**PRELIMINARY DRAINAGE REPORT AND MDDP ADDENDUM
FOR
HOMESTEAD NORTH AT STERLING RANCH PRELIMINARY PLAN**

Engineering Review

EPC Planning & Community
Development Department

**PCD Filing No.:
SP-20-008**

EX DRAINAGE MAP
HOMESTEAD NORTH
JOB NO. 25188.00
1-27-2021
SHEET 1 OF 1

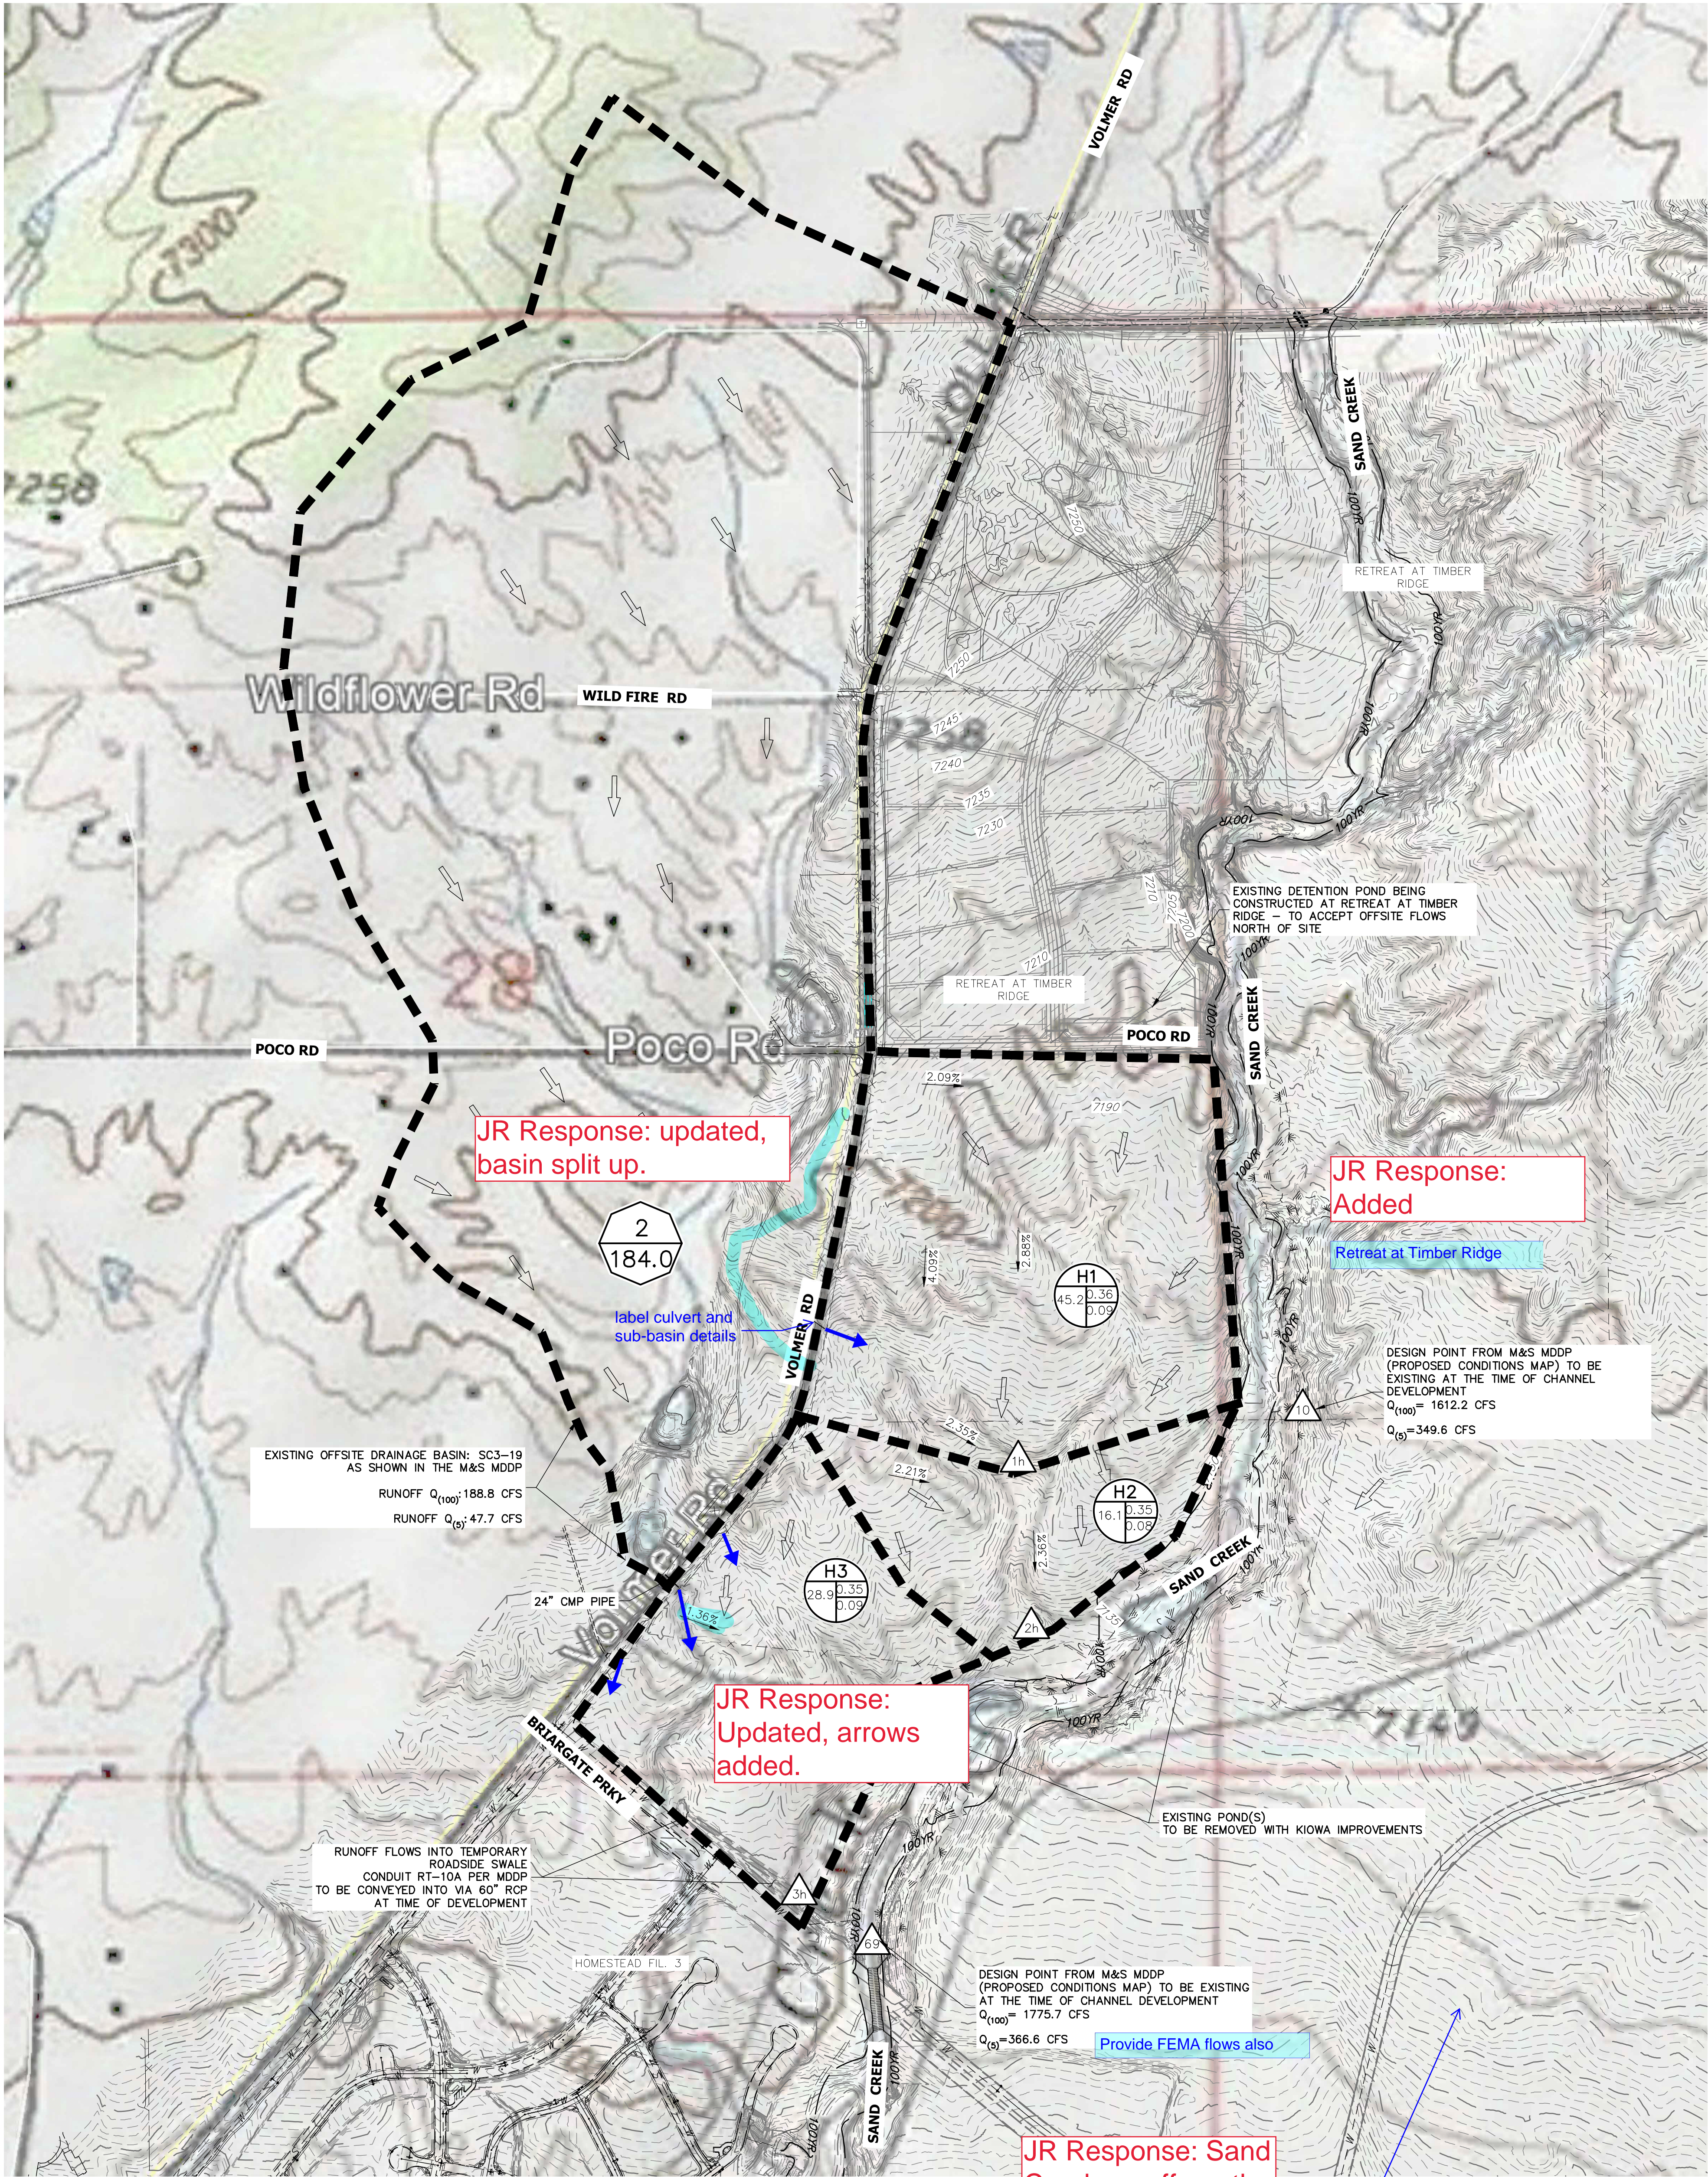
Address the existing basins around proposed Sterling Ranch Road and Briargate Pkwy.

JR Response: Existing basins added to drainage map.

EARLY GRADING - DRAINAGE MAP
HOMESTEAD NORTH
JOB NO. 25188.00
02/12/21
SHEET 1 OF 1

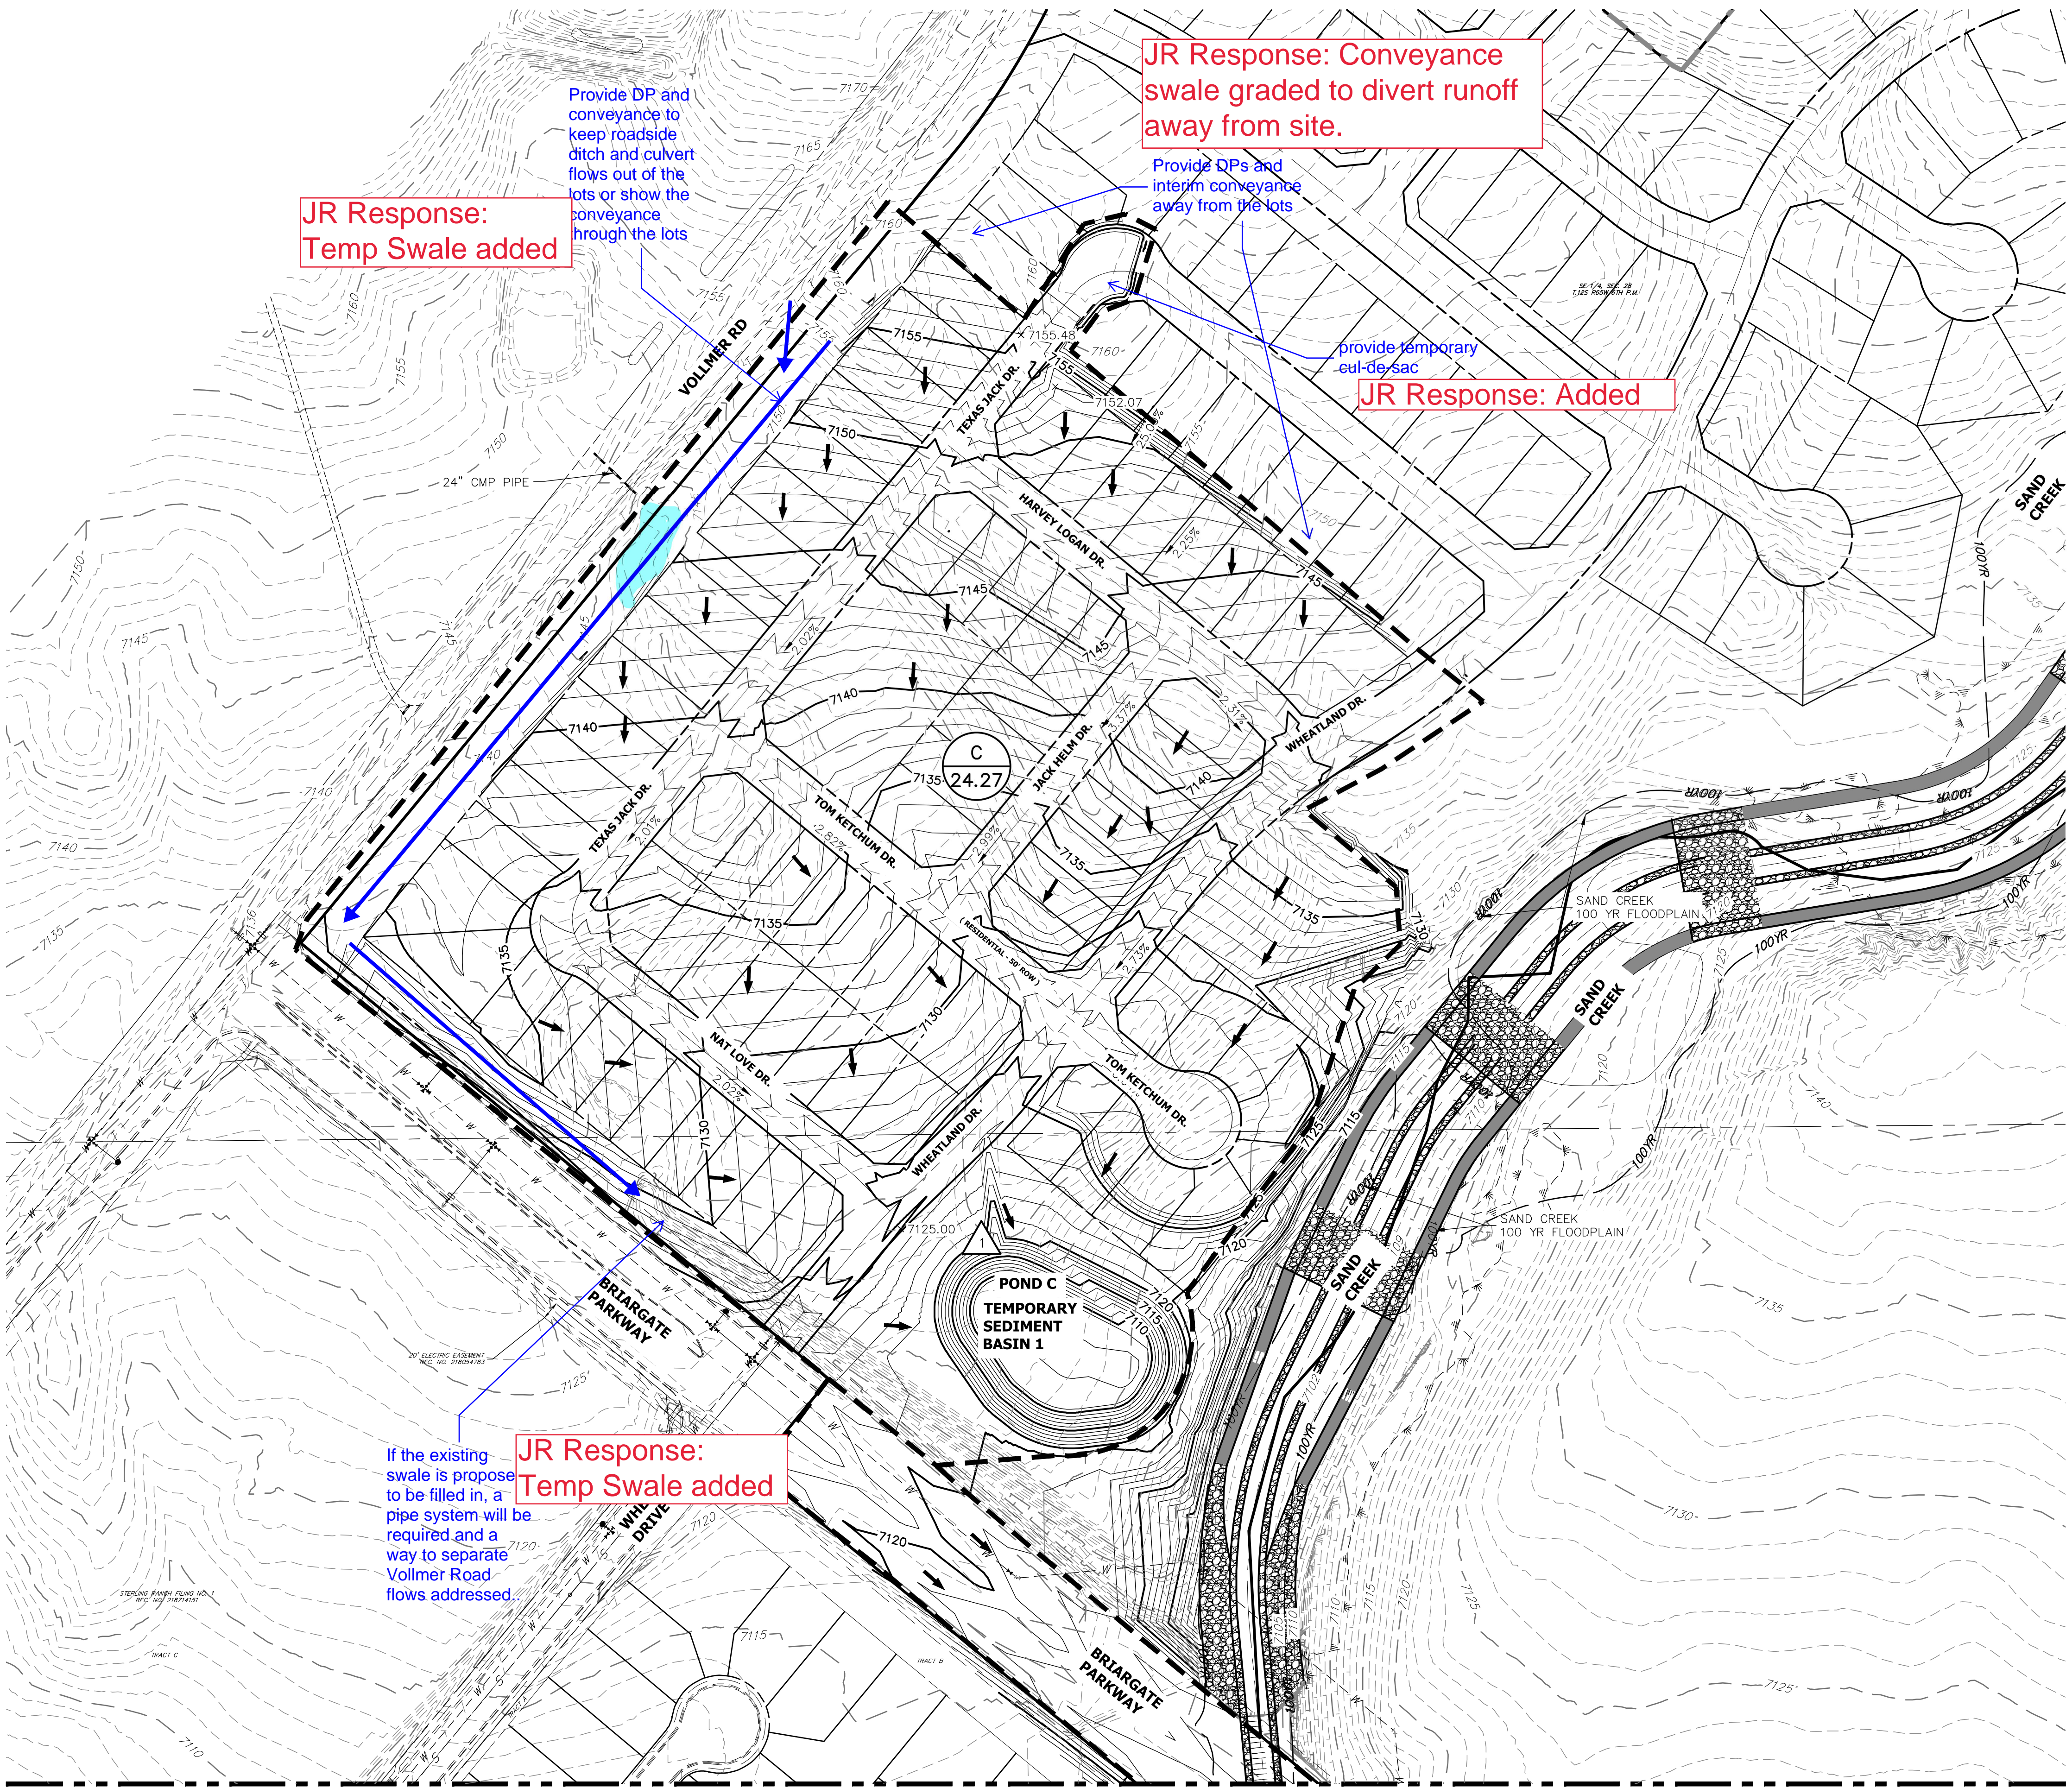
Provide basin and DP summary tables

JR Response: Added

EARLY GRADING - DRAINAGE MAP
HOMESTEAD NORTH
JOB NO. 25188.00
02/12/21
SHEET 2 OF 4

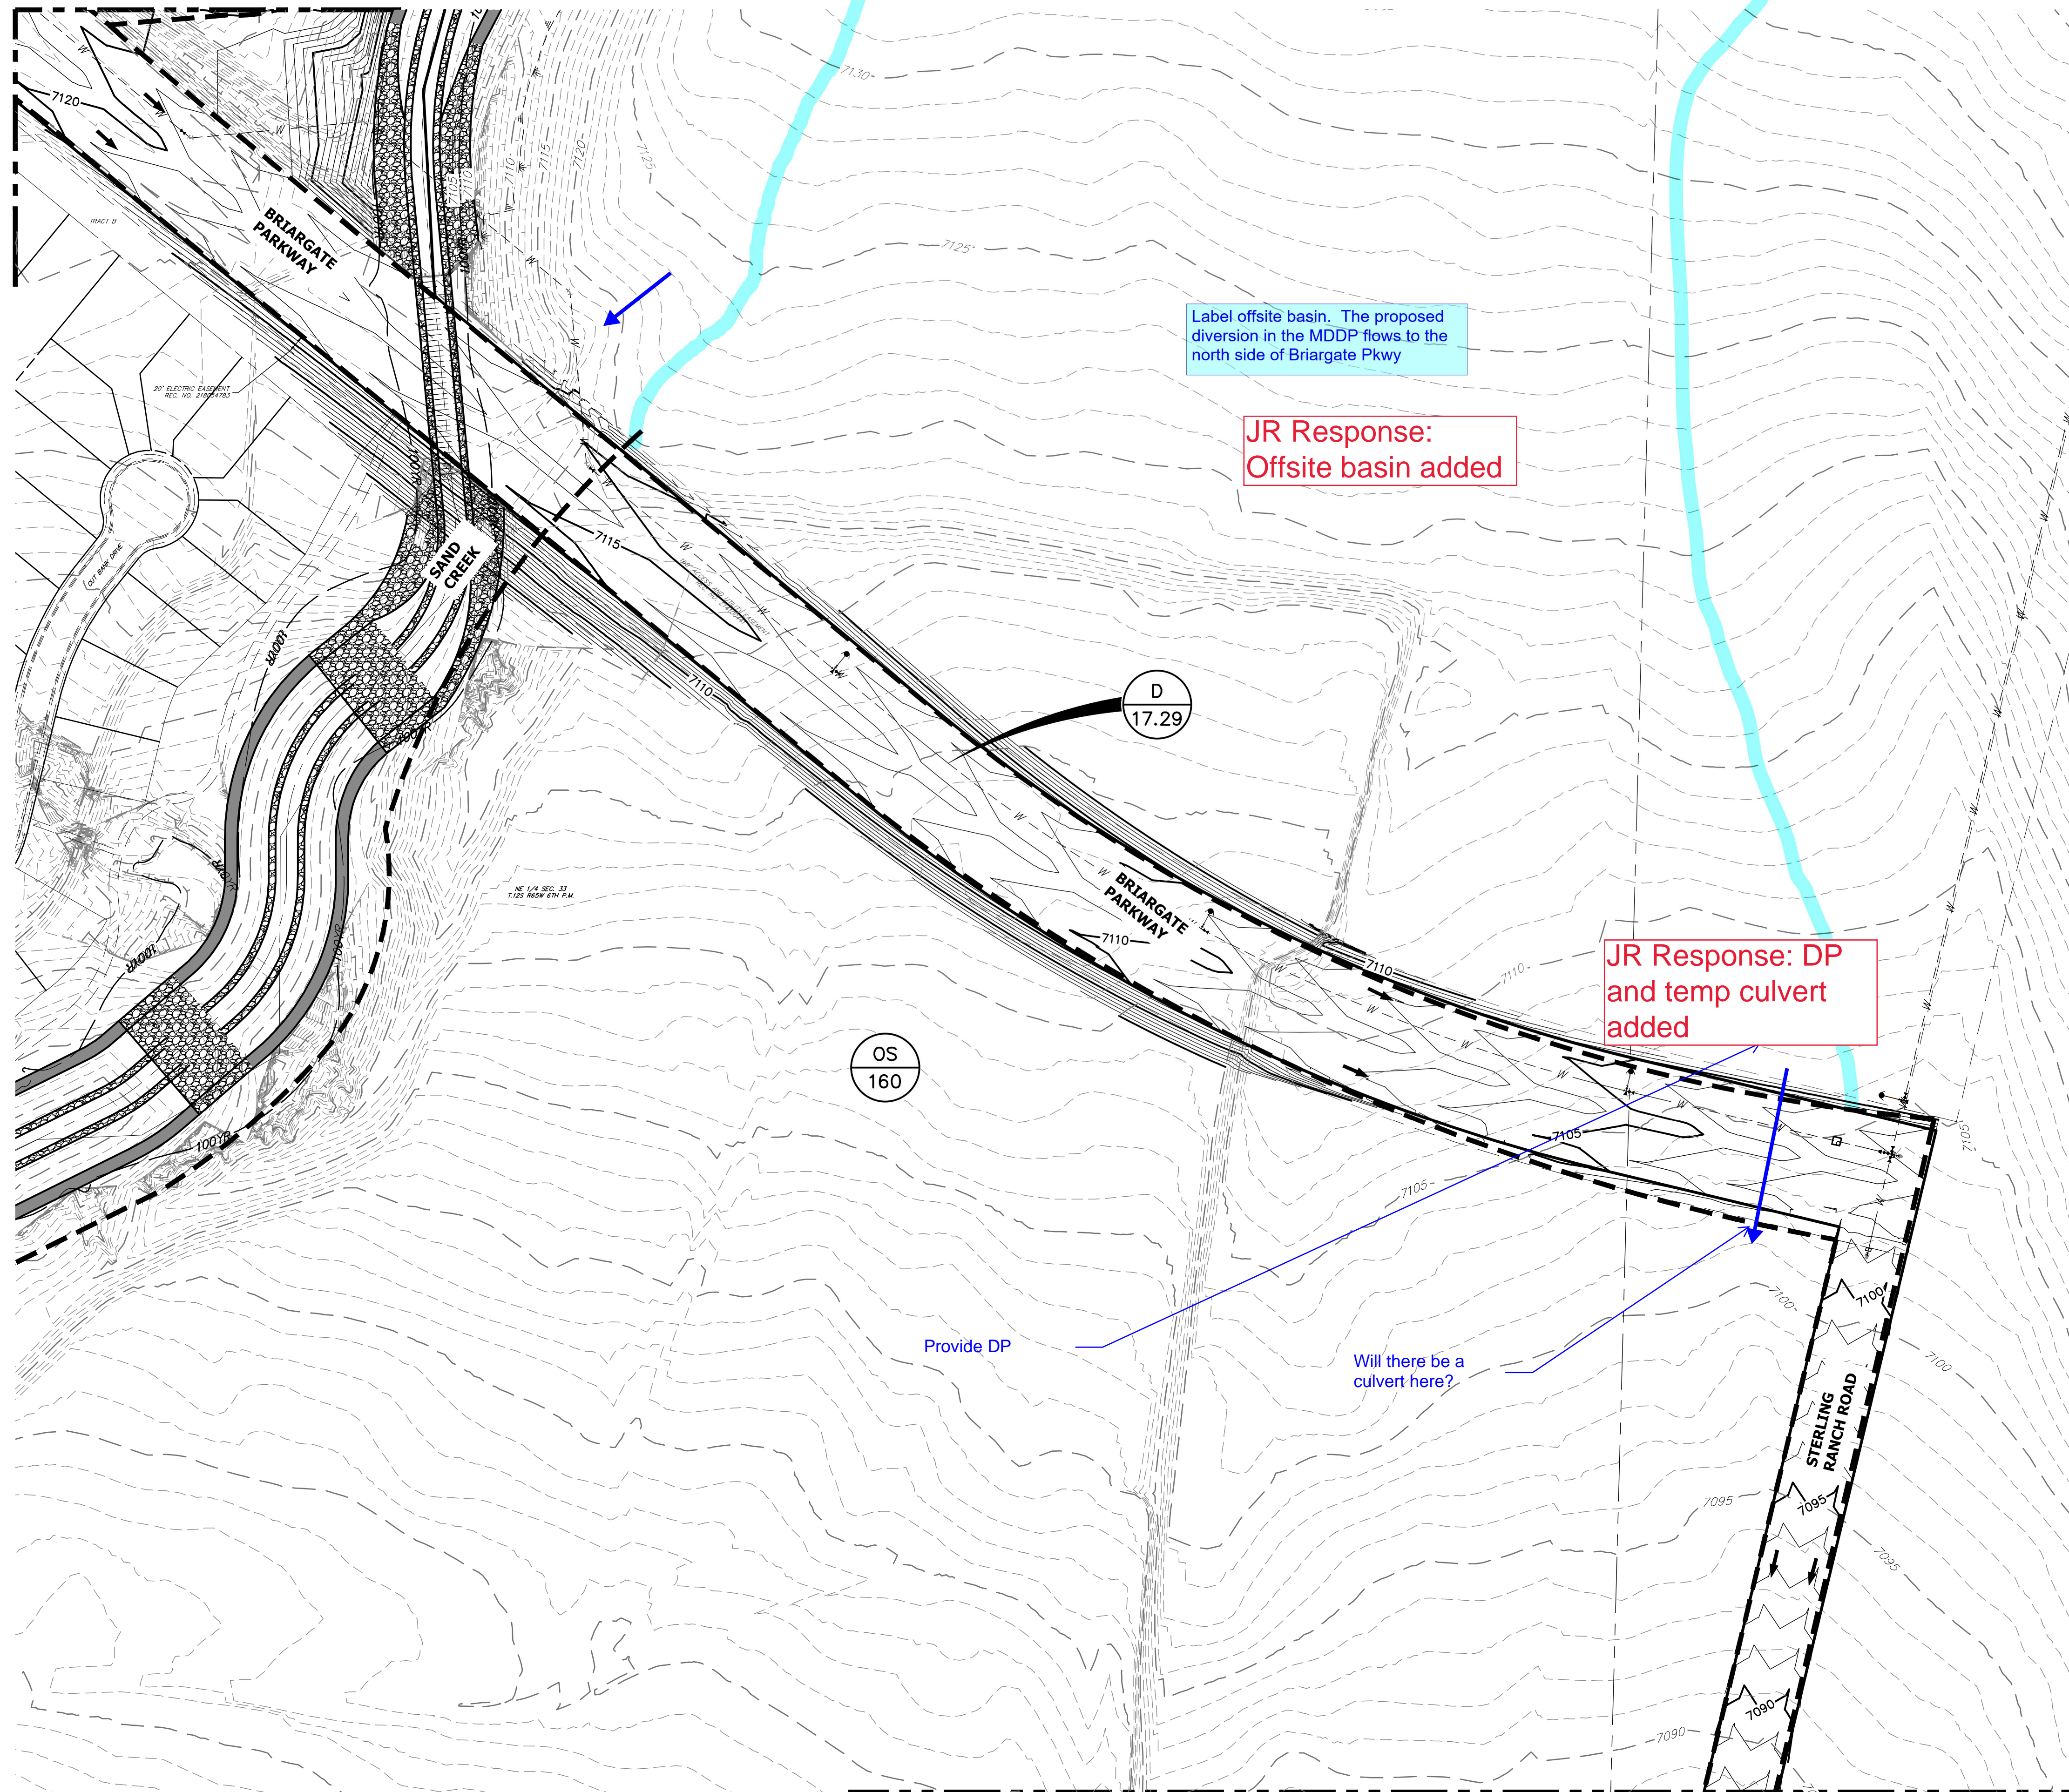
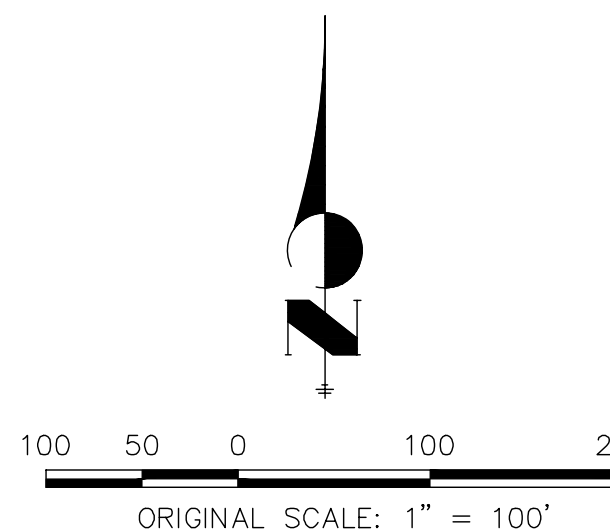
Provide basin and DP summary tables

Provide D

JR Response: Added

JR Response: DP
and temp culvert
added
